National Committee on Uniform Traffic Control Devices

National Committee on Uniform Traffic Control Devices (NCUTCD) Recommended Changes to Proposed Text for 11th Edition of the MUTCD Docket Number: FHWA-2020-0001

- 1 **Federal Register Item Number:** 185 to 227, 647
2 **NPA MUTCD Section Number:** 2E.01 to 2E.59, Appendix A1
3 **Legend:** Base text shown in proposal is the NPA “clean” proposed text.
4 • [NCUTCD recommendation for text to be added in final rule.](#)
5 • [NCUTCD recommendation for text to be deleted in final rule.](#)
6 • [NCUTCD recommendation for text to be moved/relocated in final rule.](#)
7 • [NPA text that was not previously approved by NCUTCD but is now approved.](#)
8 • Explanatory note: [Note that explains purpose of recommended change.]

Figure 2E-22. Example of Guide Signs for an Auxiliary Lane One-Half Mile or Longer

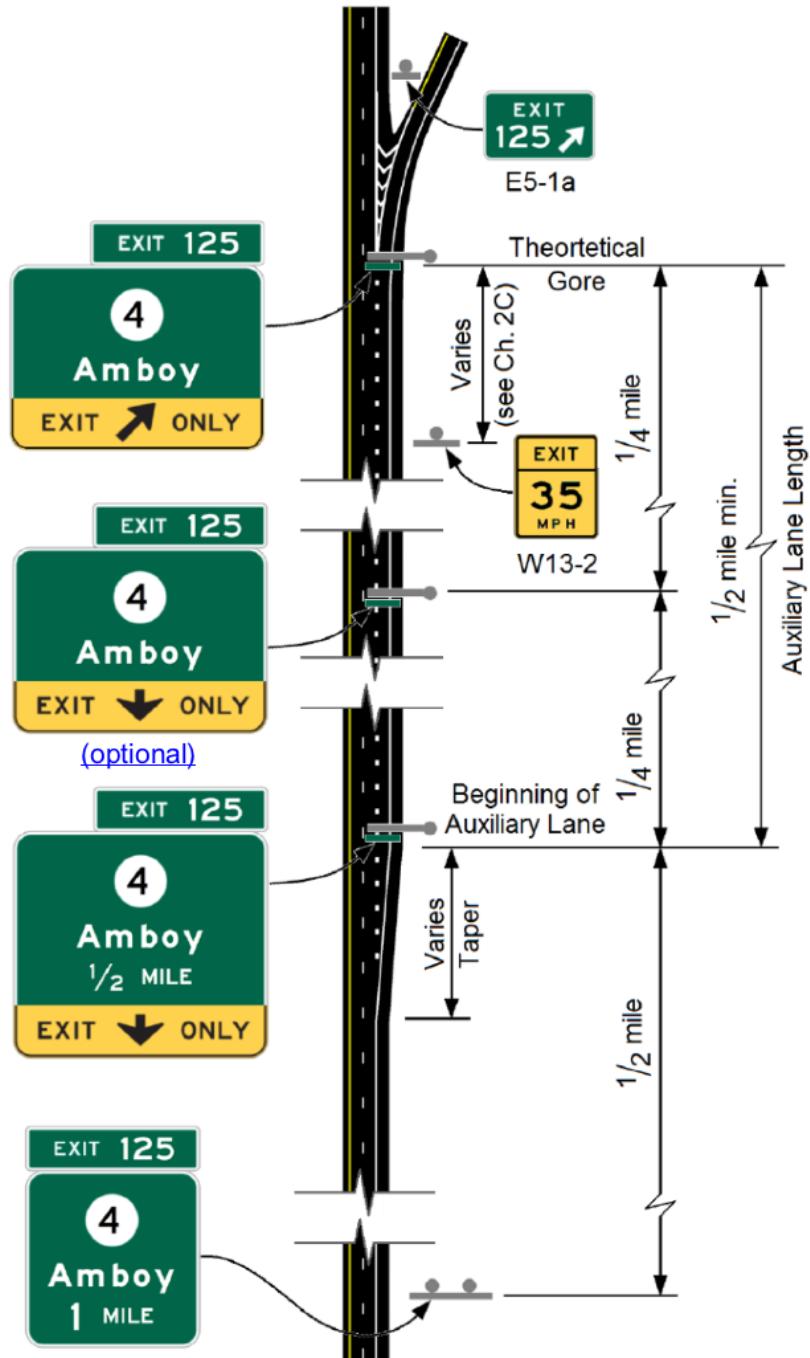
1732 NCUTCD generally agrees with Figure 2E-22 as presented in the NPA, but recommends labeling
1733 the $\frac{1}{4}$ mile Advance Guide sign as optional.

**Figure 2E-23. Examples of Signing for Mainline Lane Terminations
Downstream of an Exit Ramp**

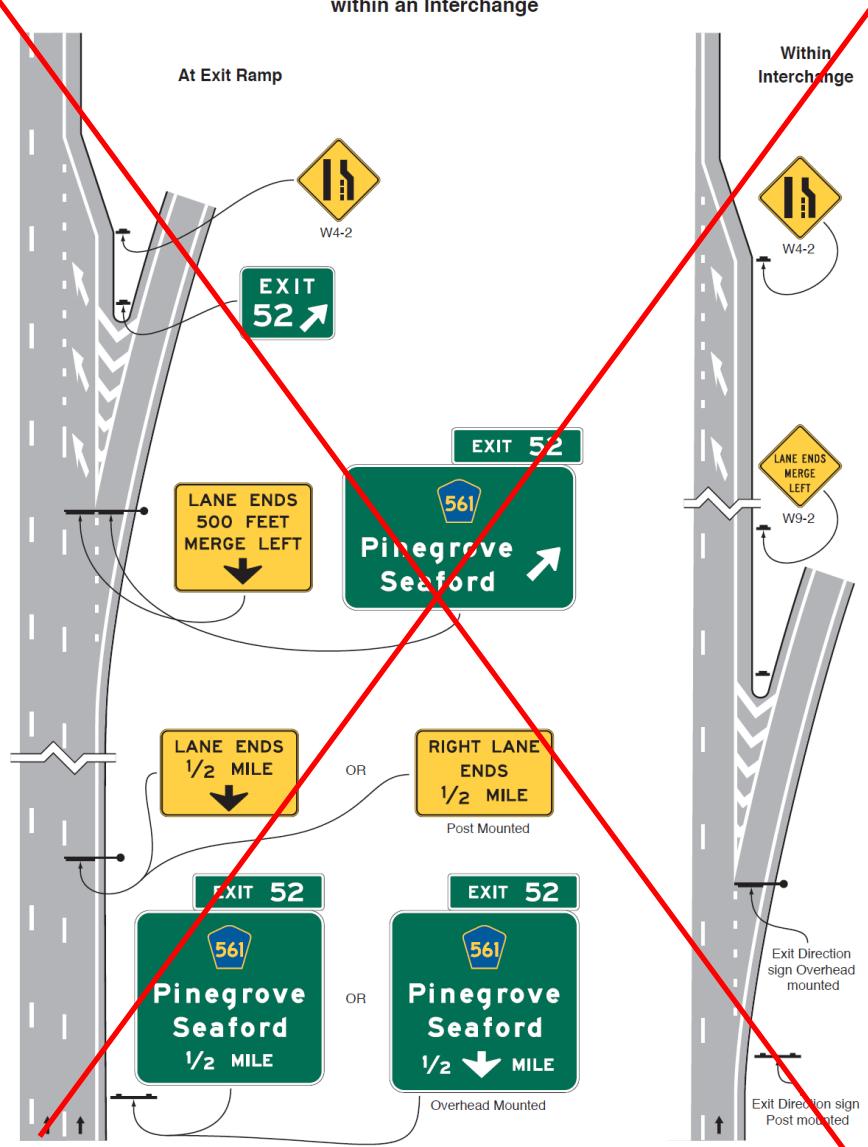
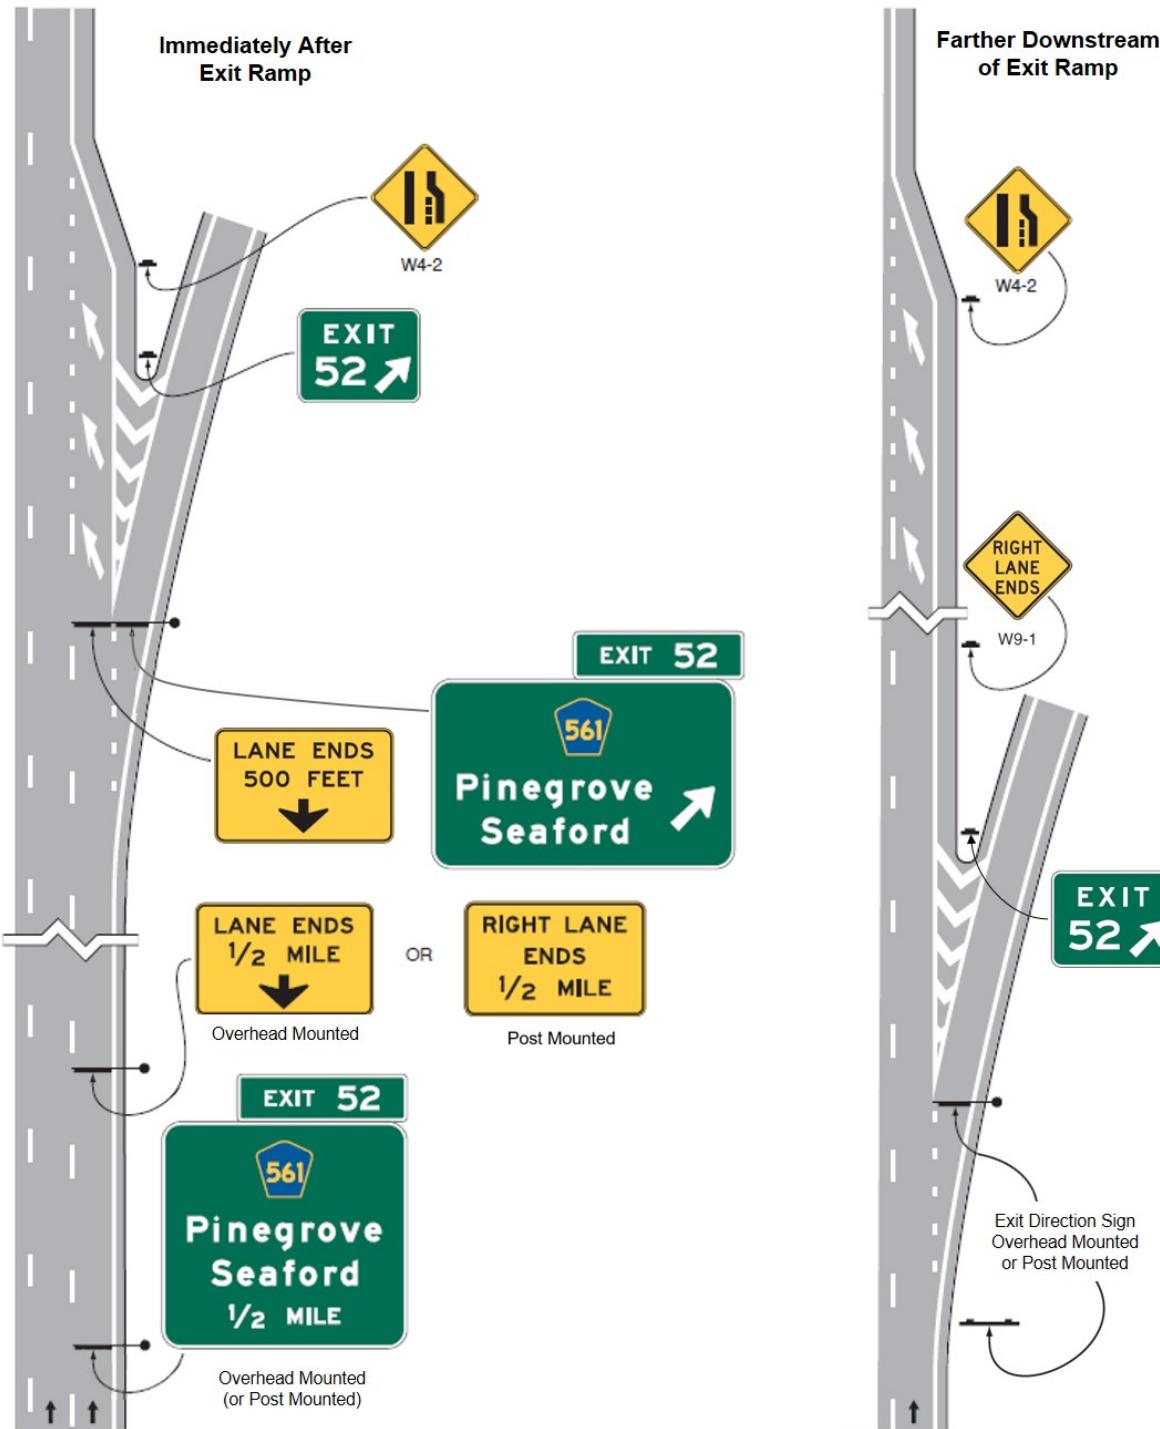
- 1737 NCUTCD recommends replacing Figure 2E-23 with a new figure revised as follows:
- 1738 • Revise title to “Examples of Signing for Mainline Lane Terminations Downstream of an Exit
- 1739 Ramp”
- 1740 • Revise “At Exit Ramp” caption to “Immediately after exit ramp”
- 1741 • Revise “Within Interchange” caption to “Farther downstream from exit ramp”
- 1742 • Replace W9-2 with W9-1 for consistency with Chapter 2C
- 1743 • Revise overhead sign to read “LANE ENDS 500 FEET” and delete “MERGE LEFT”
- 1744 • Delete the overhead sign option with the arrow splitting the distance message
- 1745 • Revise the callout on the Exit Direction sign location in the right-hand example to reduce
- 1746 confusion
- 1747 • Show all signs and dimensions consistently with other Figures in other chapters of the
- 1748 MUTCD related to lane ends signing and markings

1798
1799 Figure 2E-24. Example of Signing for an Intermediate Interchange
within a Major Interchange

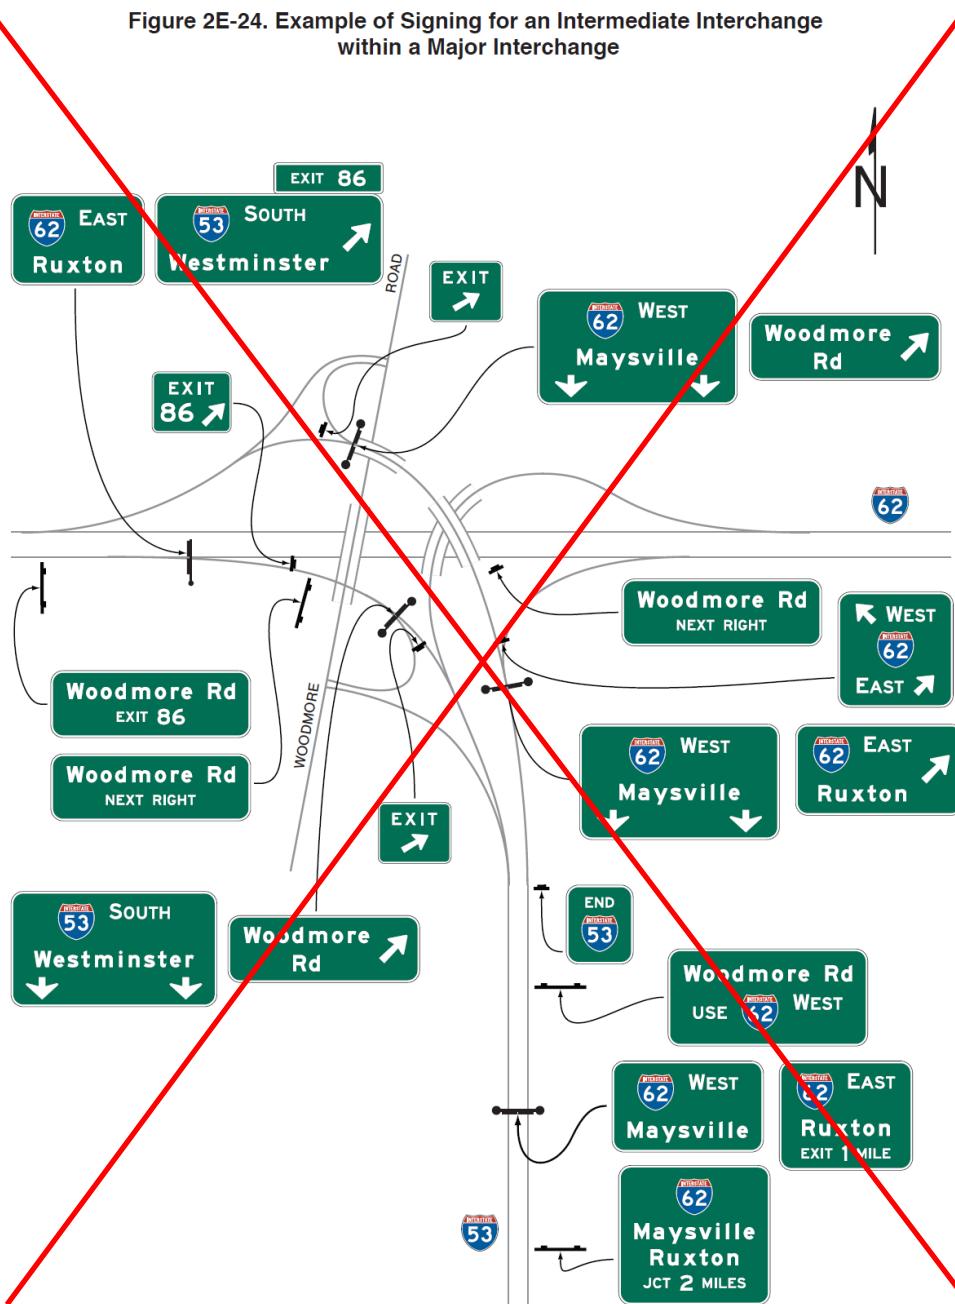
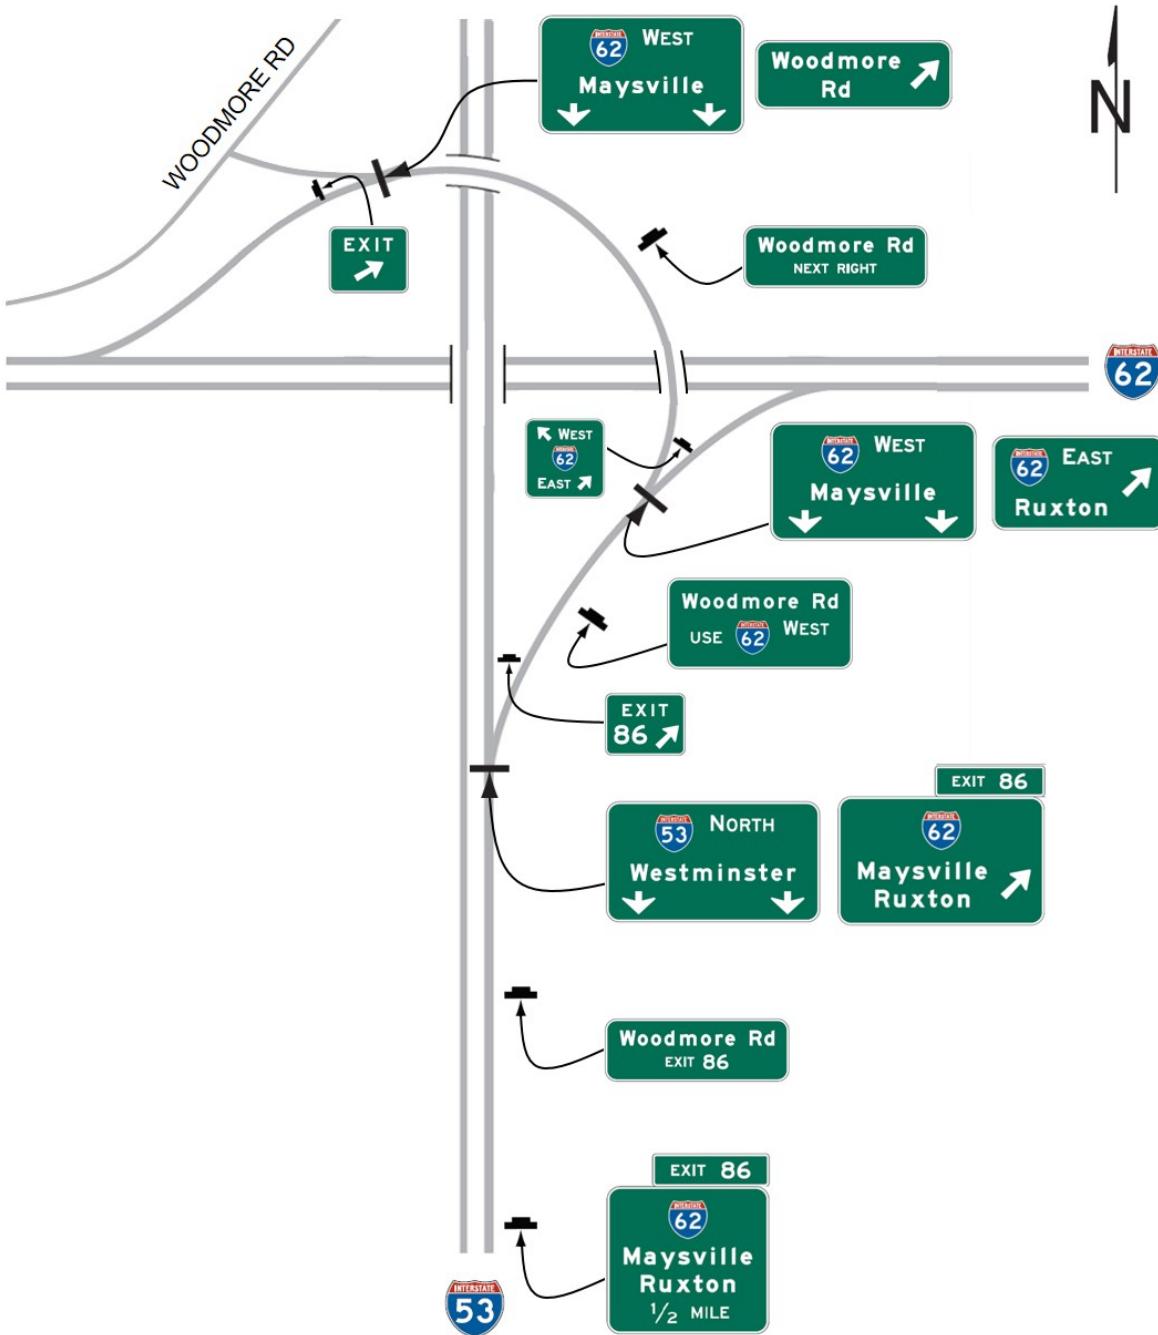
1792 NCUTCD recommends replacing Figure 2E-24 with a new figure revised as follows:

- 1793 • Revise the basic signing condition to depict a standard through freeway and not a freeway
1794 termination
- 1795 • Remove signing for a second freeway, as it unnecessarily complicates the figure
- 1796 • Include exit numbering on the primary freeway
- 1797 • Revise and simplify leader lines so as not to be confused with roadway lines

**Figure 2E-25. Examples of Signing for an Interchange Exit Ramp
with a Downstream Split (Sheet 1 of 2)**

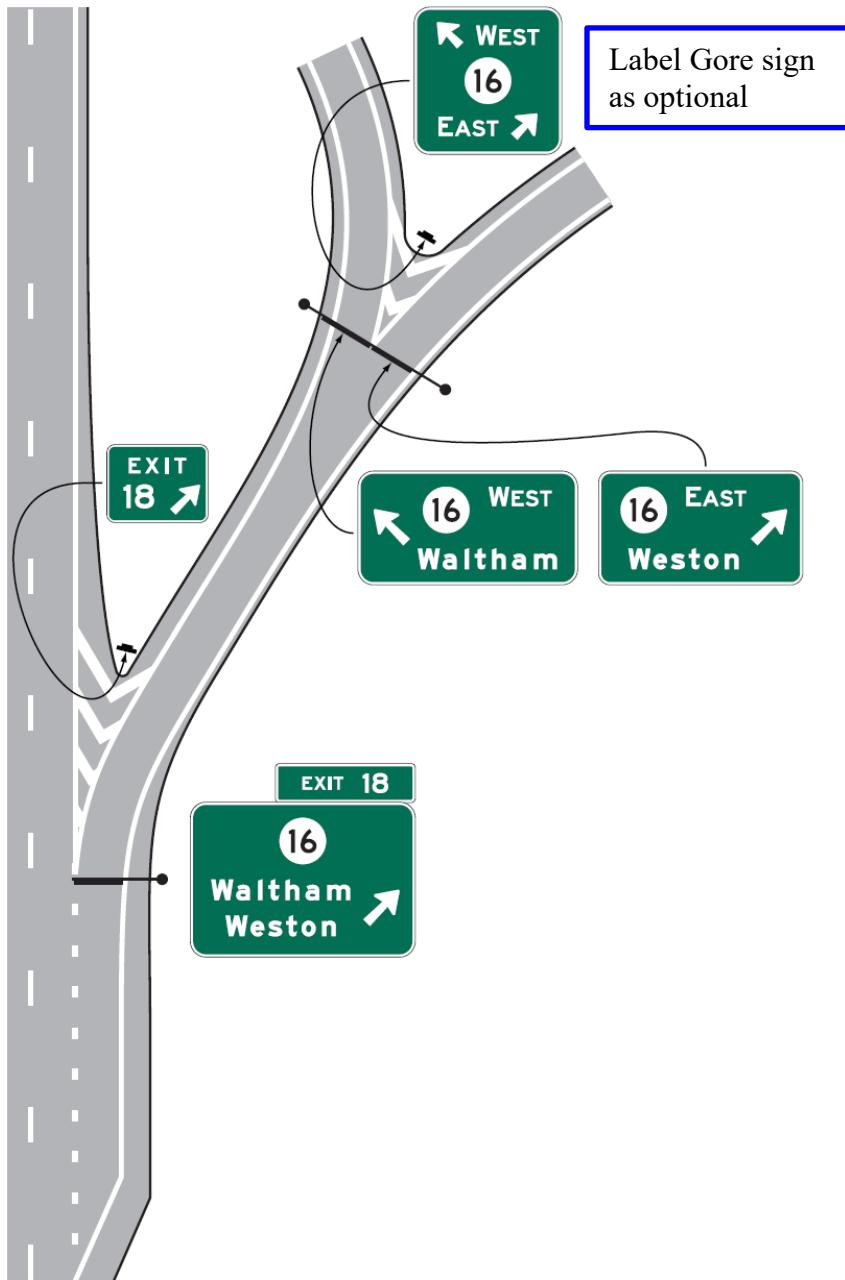
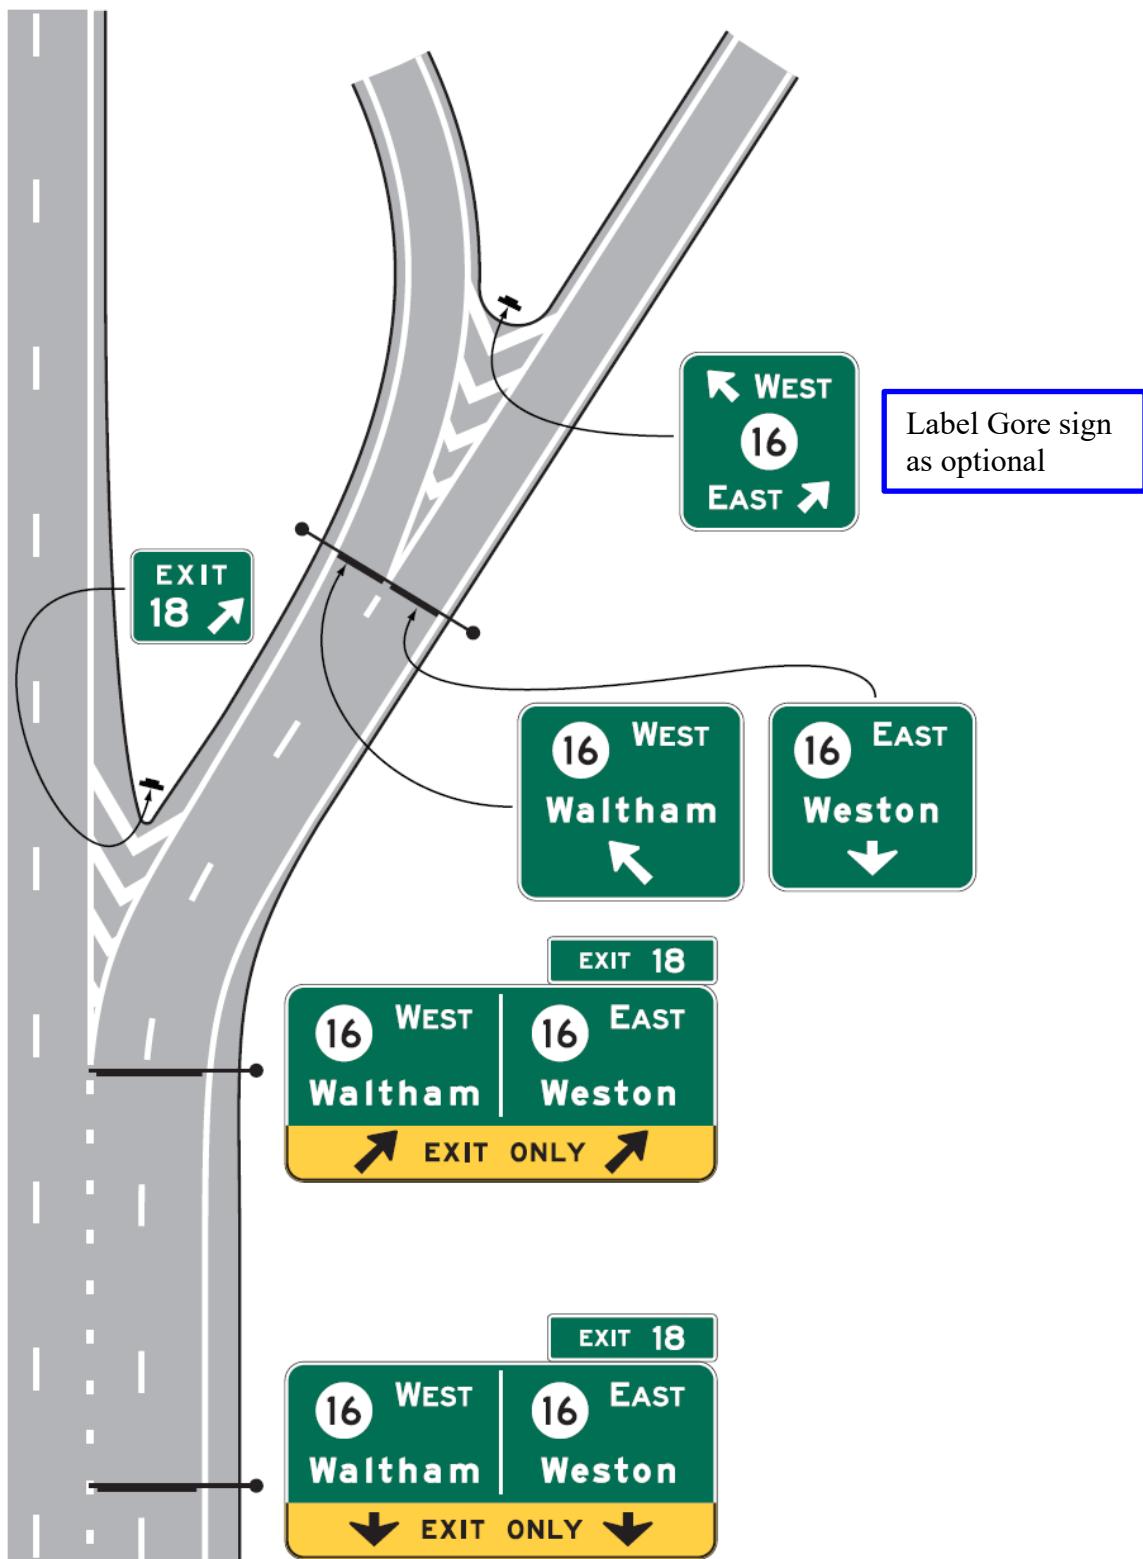
1802 NCUTCD generally agrees with Figure 2E-25 as presented in the NPA, but recommends labeling
1803 the gore signs as optional.
1804

Figure 2E-37. Overhead Arrow-per-Lane Guide Signs for a Two-Lane Exit to the Right
with an Option Lane (Through Lanes Curve to the Left)

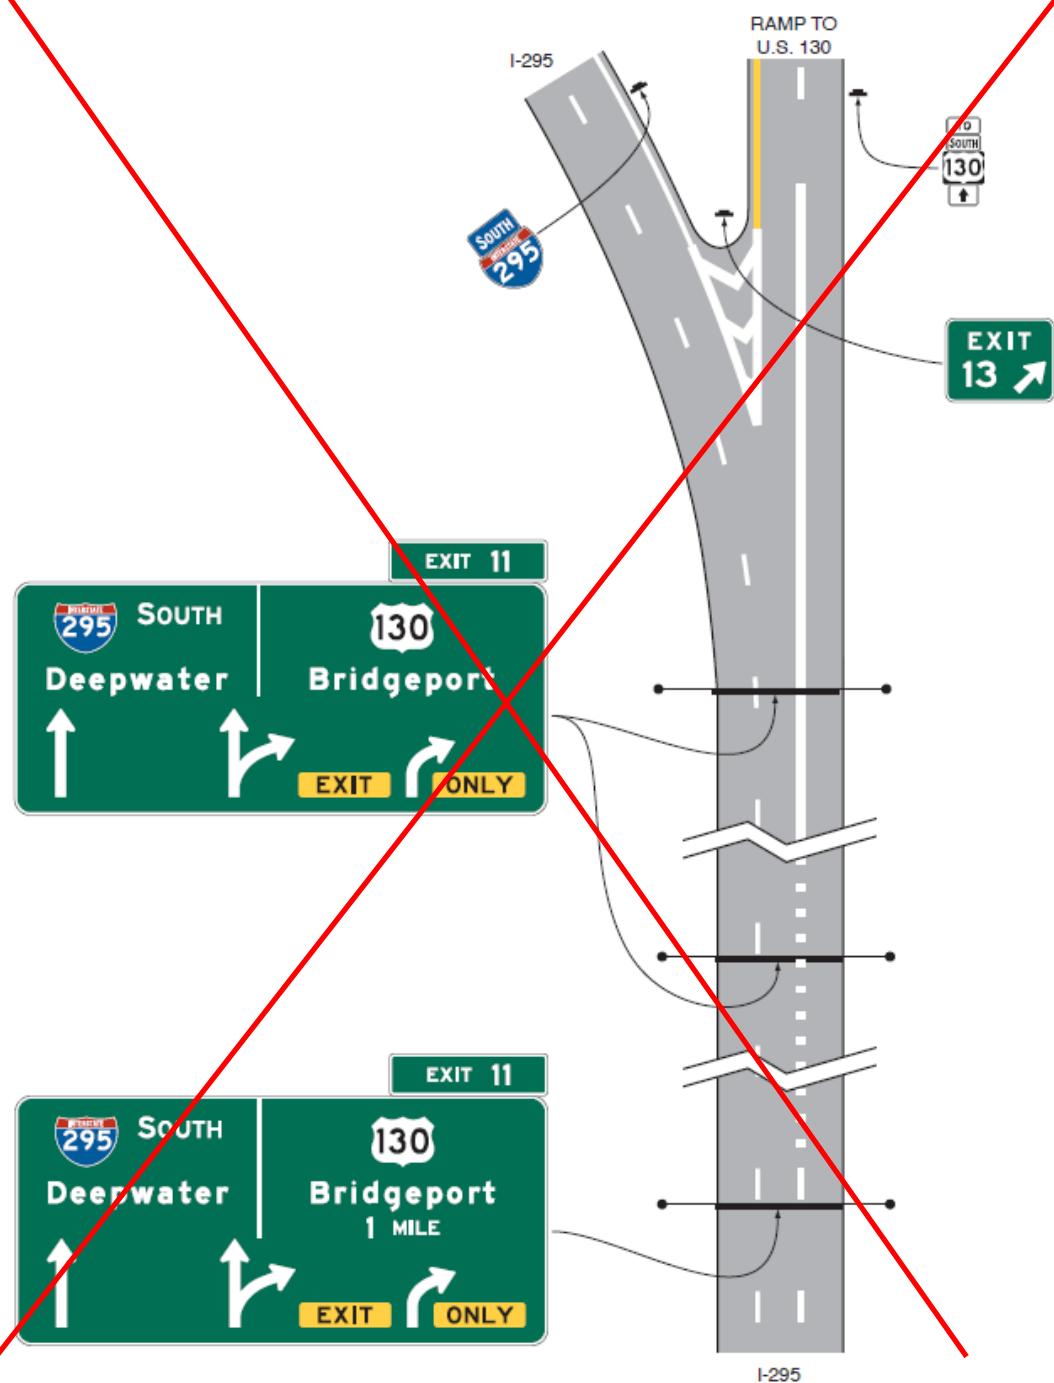
2298 NCUTCD recommends deleting Figure 2E-37 as presented in the NPA, as using curved arrows
2299 for a geometrically straight movement and straight arrows for a geometrically curved movement
2300 contradicts driver expectations, violates guidance for arrows elsewhere in the MUTCD, violates
2301 Standards in 2E.40, and is inconsistent with other Chapter 2E figures.
2302
